MAF200 Series Body Design Change

MAF200 Series Air Unit

MAF200 series:

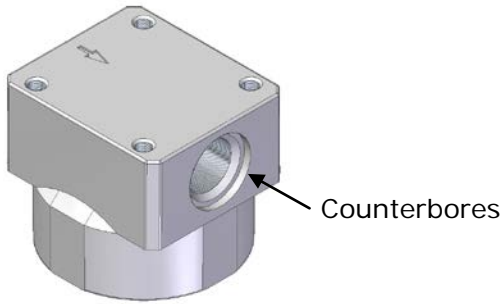
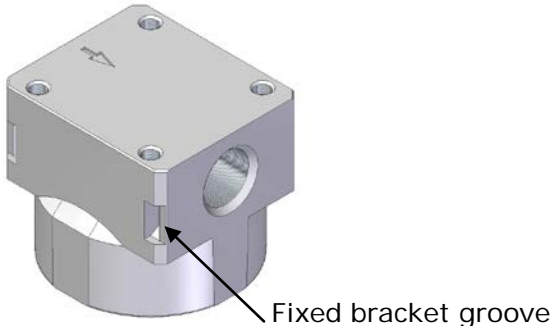
In order to add MACT200 series, change the MAF200 body exterior design.

Before	After
with counterbores, no fixed bracket groove	with fixed bracket groove , cancel counterbores
